REVISIONS		
#	DESCRIPTION	DATE
1	SUPPLEMENTAL INFORMATION #2	5/10/2018

NEW BUILDING FOR BAKERY - PICKUP & DELIVERY

SHEET TITLE:
WOOD FRAME VENT

DRAWING NUMBER:
S-3

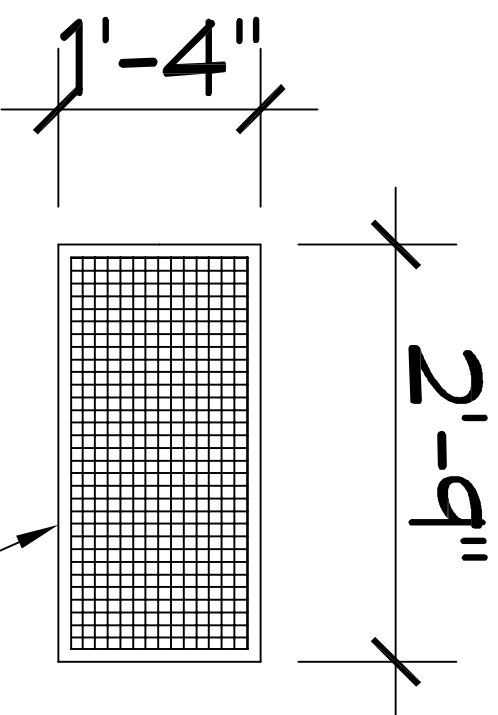
**NOTE: INSTALL 1/4" STEEL LINTEL ABOVE VENT HOLE.
REPLACE ANY BLOCKS THAT ARE
DAMAGED WHEN ADDING VENTS.**

**2" X 4" TREATED WOOD FRAME VENT
WITH 1/8" MESH SCREEN. USE (6) 1/4" X 2 1/2"
LAG BOLTS TO BLOCKS. CAULK AROUND
EDGES OF BLOCK TO WOOD TO MATCH
COLOR OF HOUSE.**
